Customer	: CU-DAR001 Dart Helicopters Services	Drawing Name	: HELI UTILITY BASKET LH/RH 350/355
Job Number	: 36411		
Estimate Number	: 10208		
P.O. Number	: N/A	Part Number	: D350607043
This Issue	: 12/18/2007 S.O. No. : N/A	Drawing Number	: D350-607 REV F P7-9
Prsht Rev.	: NC	Project Number	: N/A
First Issue	: N/A Type : LARGE FAB ASSY	Drawing Revision	: F
Previous Run	: 35574	Material	: N/A
Written By	:	Due Date	: 1/12/2008 Qty: 1 Um: Each
Checked & Approved By	: <u>07.12.18</u>		
Comment	: Est Rev. E as Per DSI9318 06-01-24 JLM

DESIGN <i>CP</i>	DRAWN BY <i>CP</i>	DART AEROSPACE LTD HAWKESBURY, ONTARIO, CANADA	
CHECKED <i>[Signature]</i>	APPROVED <i>[Signature]</i>	DRAWING NO. DSI 9318	REV. A SHEET 1 OF 1
DATE 06.01.06		TITLE WASHER ADDITION	SCALE NTS
A	06.01.06	NEW ISSUE

DART SERVICE INSTRUCTION

TO AMEND INSTALLATION INSTRUCTIONS D350-607 REV. F

Figure 5- Basket Replacement Parts
(D350-607-043 Heli-Utility-Basket™)

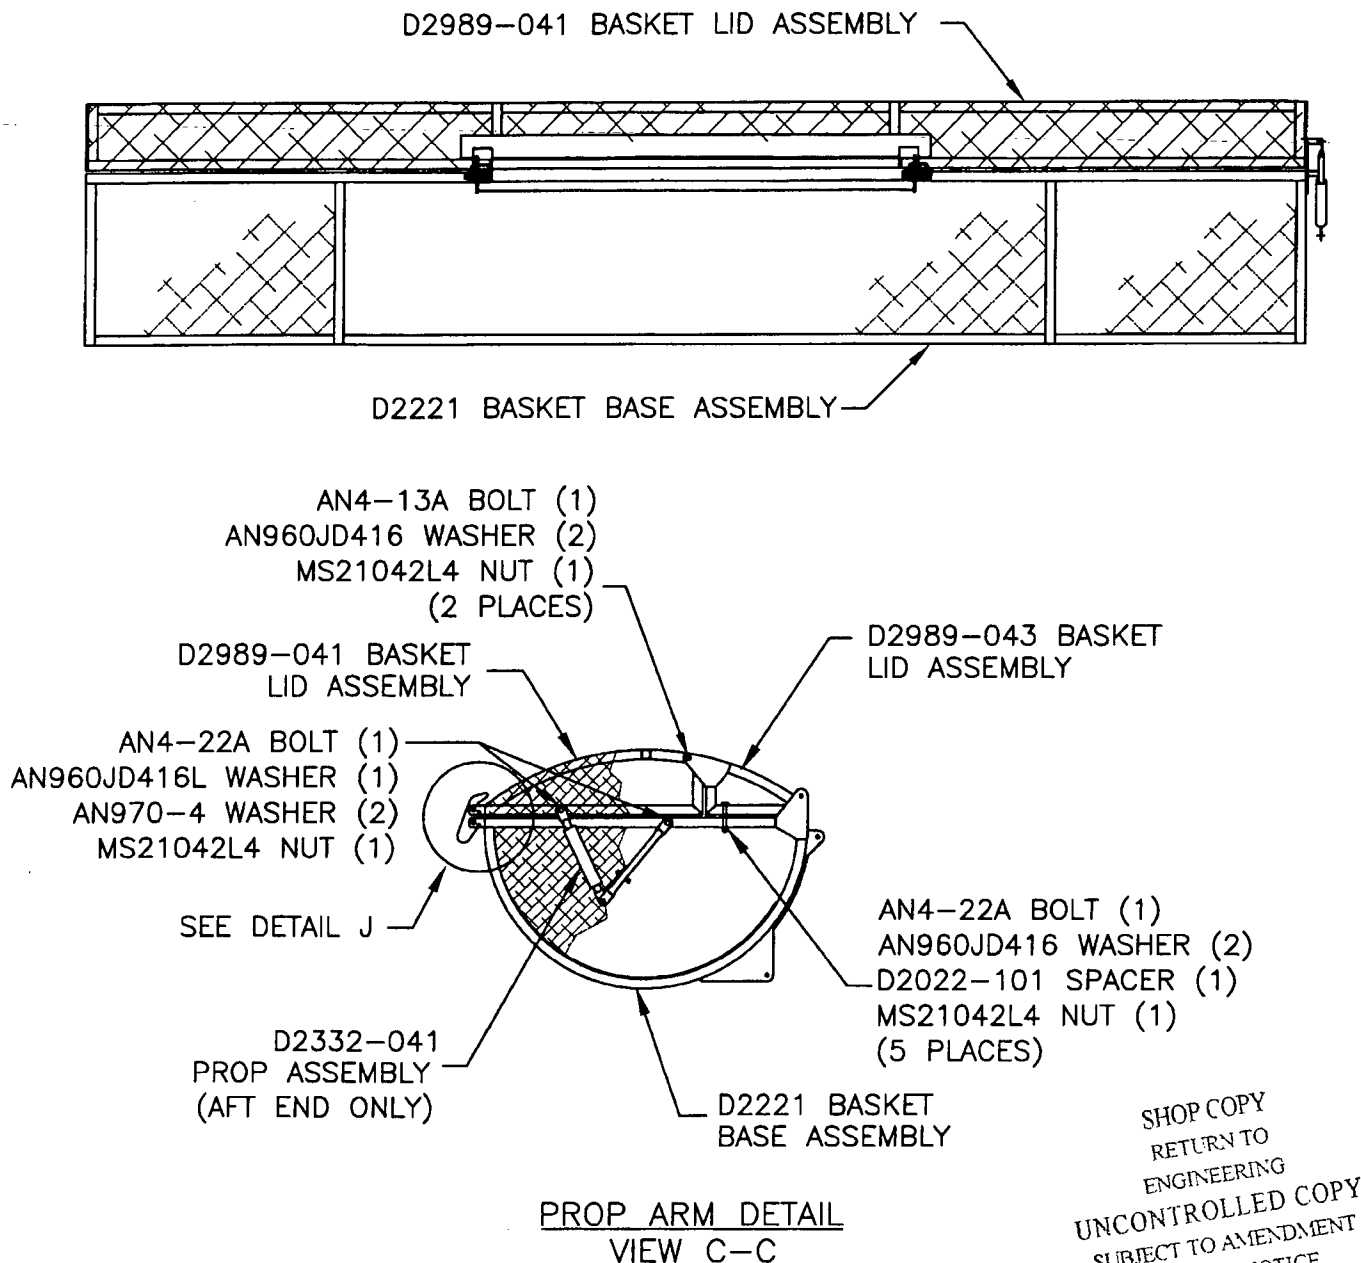
To reduce the possibility of damaging the finish, a **NAS1515H4** washer (2 places) has been added between the hinge plate and basket frame on the **D350-607-043/-047 Heli-Utility-Basket**.

The corrected bolt stackup from Figure 5 of installation instructions D350-607 Rev. F is given below:

AN4-13A BOLT (1)
AN960JD416 WASHER (1)
HINGE PLATE (REF)
NAS1515H4 WASHER (1)
BASKET FRAME (REF)
AN960JD416 WASHER (1)
MS21042L4 NUT (1)
(2 PLACES)
